Re: PowerStream Inc. Custom IR Application 2016 to 2020
AMPCO Final Submission
Board File No. EB-2015-0003

**Application for electricity distribution rates for the period
from January 1, 2016 to December 31, 2020.**

AMPCO Submissions

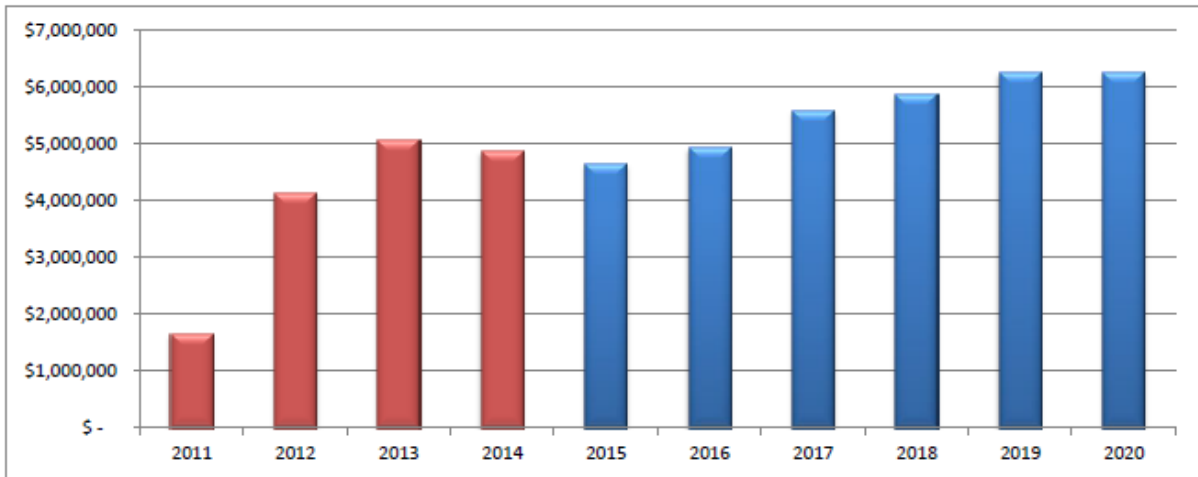
PowerStream was assisted by and BIS Consulting in 2009 and Kinectrics in 2009 and earlier to develop an ACA. Since then, PowerStream alone has made revision versions to the original 2009 ACA report. Revision 1 on March 8, 2012; Revision 2 on November 27, 2012 and Revision 3 on December 31, 2014. PowerStream's 2016 to 2020 investment plan is based on its own 2014 ACA.

PowerStream did not have its ACA prepared or reviewed by an independent party for this application. AMPCO submits parties would have benefited from Kinectrics involvement (or other third party) in the preparation or review of PowerStream's latest ACA.

Below AMPCO provides examples where PowerStream is proposing to replace too many assets.

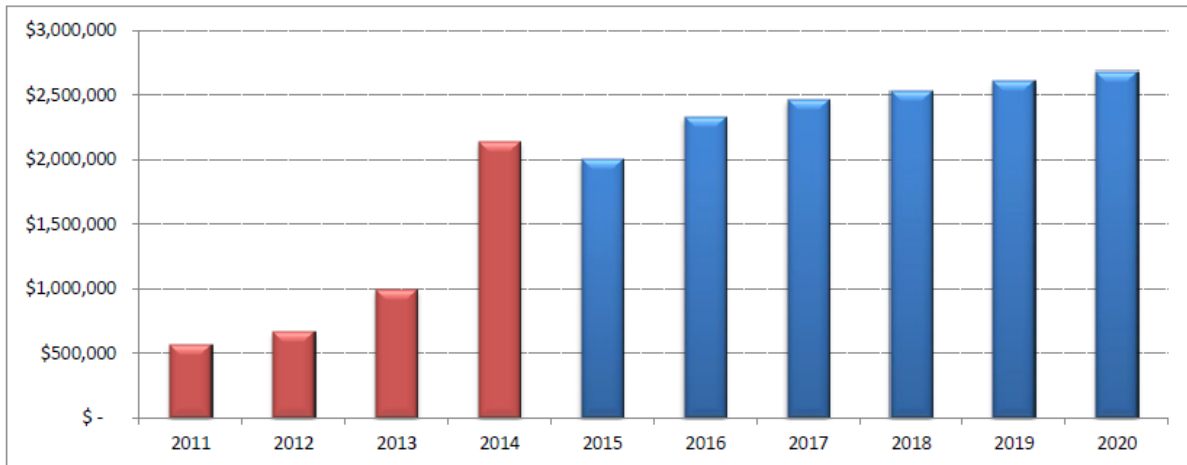
PowerStream’s Project Investment Summary #100859 indicates that switchgear units that have a “Poor” health index condition are proposed for replacement.

PowerStream proposes to replace 31 switchgears in 2015 and 36 for each of the years 2016 to 2020 for a total of 211 replaced switchgears between 2015 and 2020.³⁶
